Lower Colorado River Authority
3700 Lake Austin Blvd.
Austin, TX 78703

RE: Burnet Quarry
Application #2024-5606 U3 (Update 3)
Address: 3221 FM 3509, Burnet, TX 78611

We have reviewed the plans for the referenced permit application. The project proposes the use of Quarry Pits to meet the Performance Standards established by LCRA's Highland Lakes Watershed Ordinance. We have the following comments regarding the plans and application:

7.0 Well & Spring Inventory

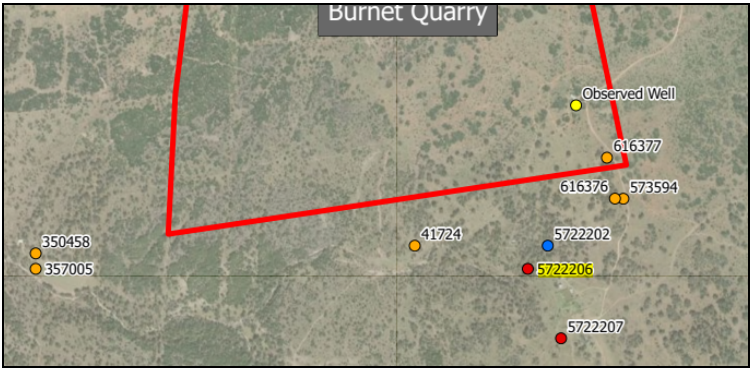
55. Update the following statement, if the location of this specific well was confirmed. *Well 164367 is mapped onsite, however the well address is for a location north of FM 3509. No evidence of this well was observed during the field investigation.*

U1- Comment addressed.
